2007 Development Agreement Amendment - Exhibit C2

2007 Development Agreement Amendment - Exhibit C1

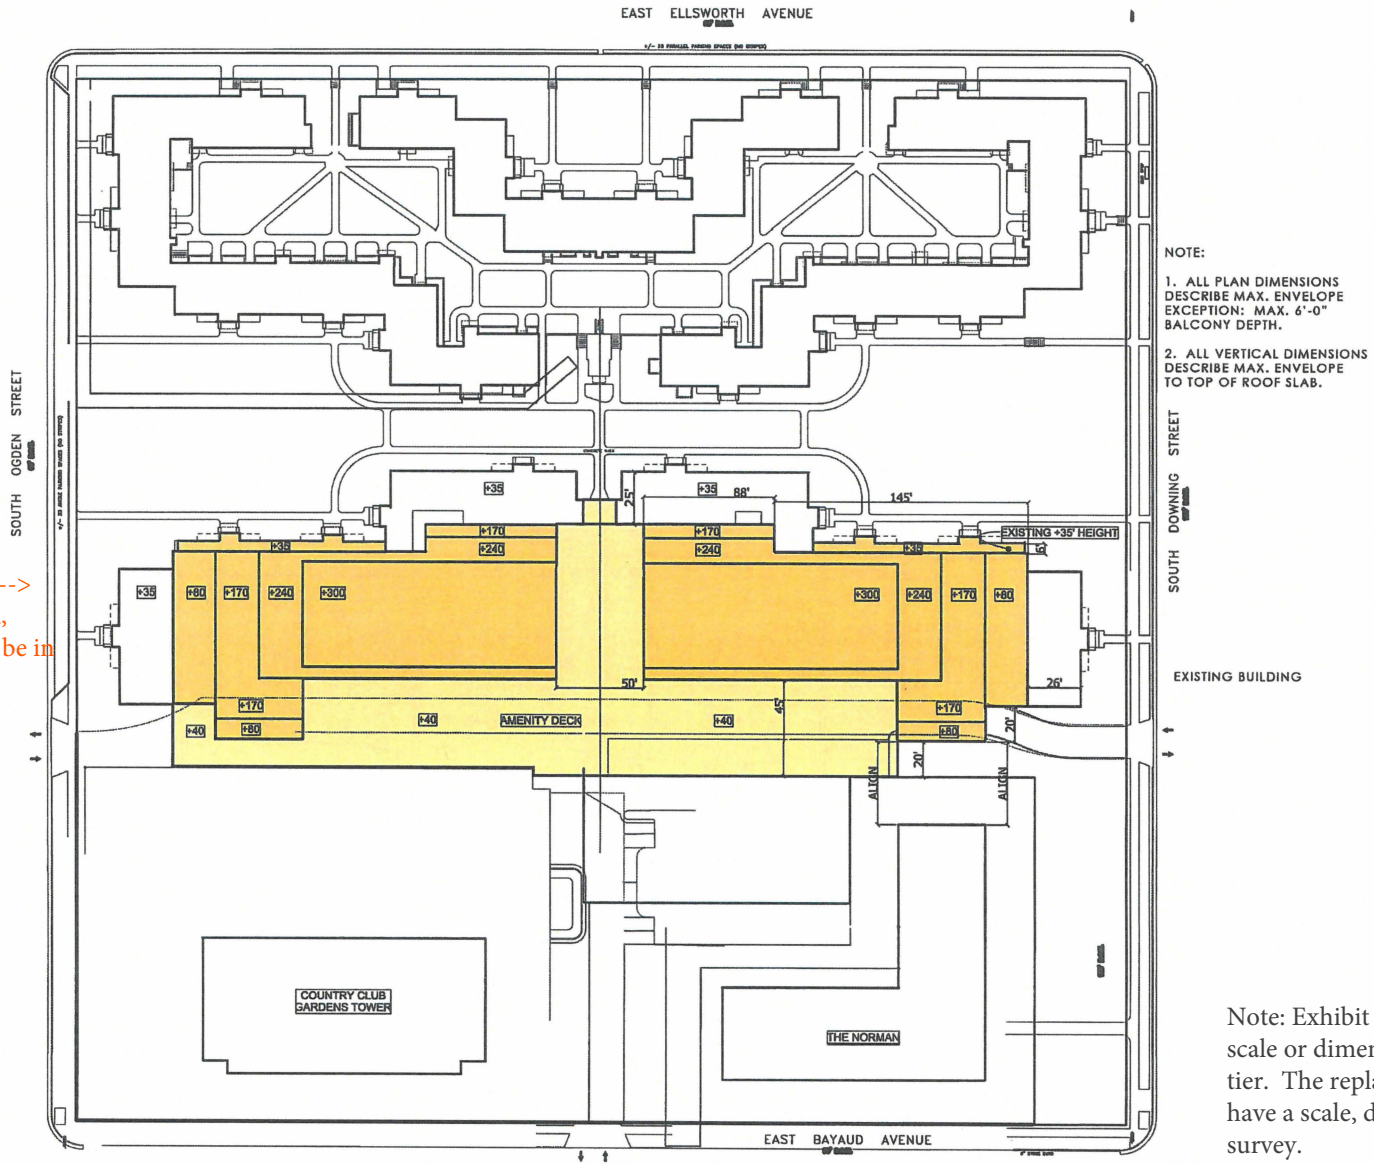
Issue 3: ----->
6' facades are shaded, suggesting they may be in development area

Issue 1: Document does not clarify how base height level is measured, making it difficult to determine true heights of height tiers on this exhibit, i.e. + 300'

<-Issue 2: How to measure 300' & whether this includes mechanical equipment

Note: Exhibit does not include a scale or dimensions for each height tier. The replacement exhibit will have a scale, dimensions and a survey.

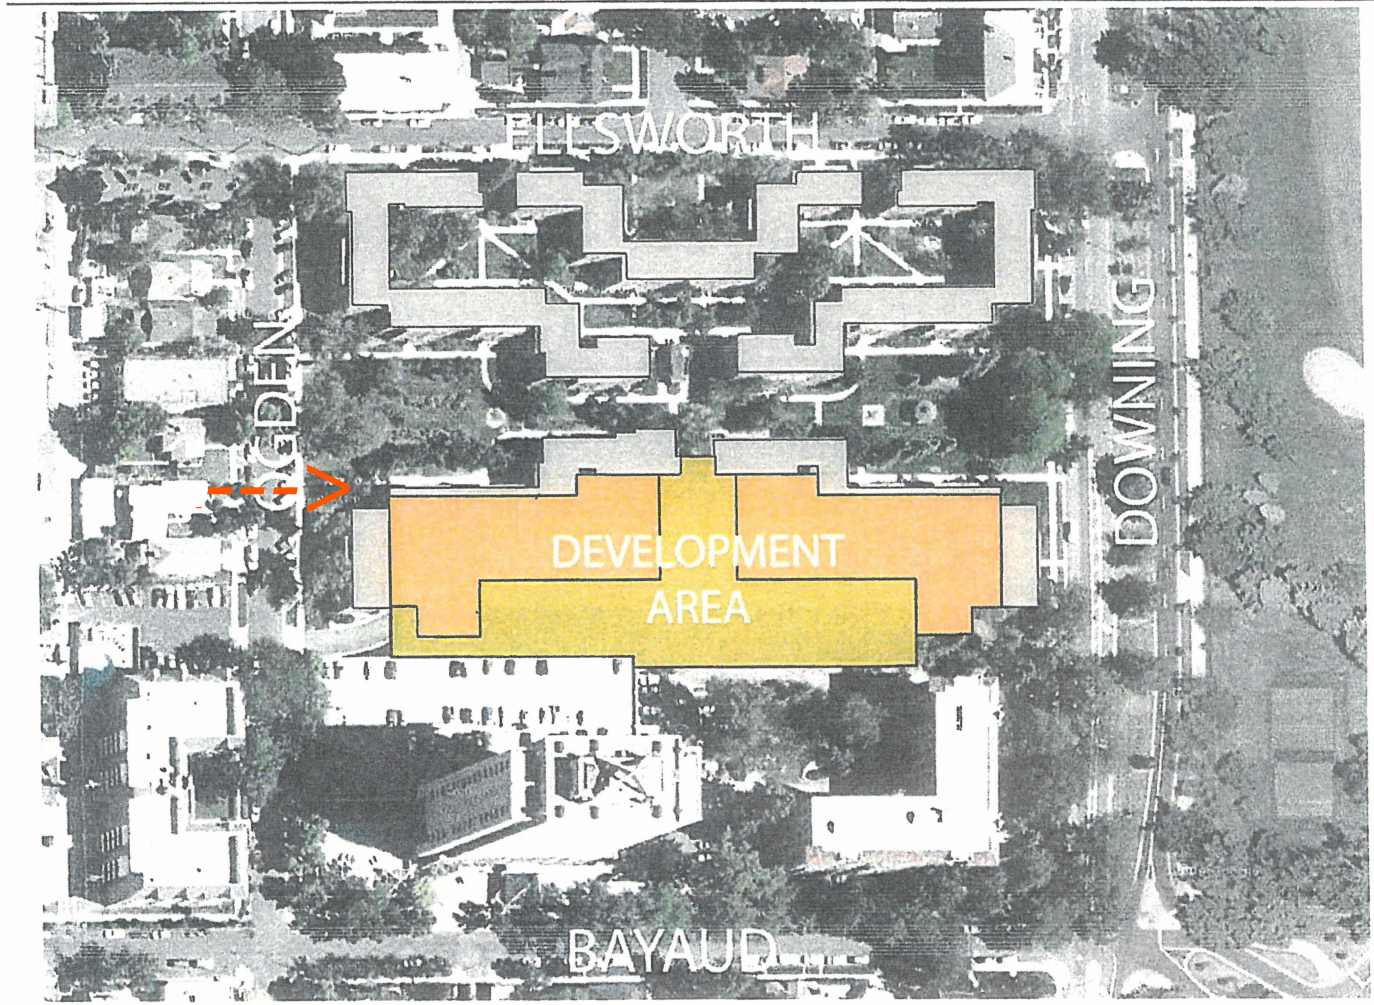
Issue 3: ----->
6' facades are not shaded,
suggesting they are not in
the development area.

Issue 2: How to
measure 300' and
whether this
includes
mechanical
equipment

Note: Exhibit does not include a scale or dimensions, making it difficult to ascertain the true development area boundaries. The replacement exhibit will have a scale, dimensions and a survey.
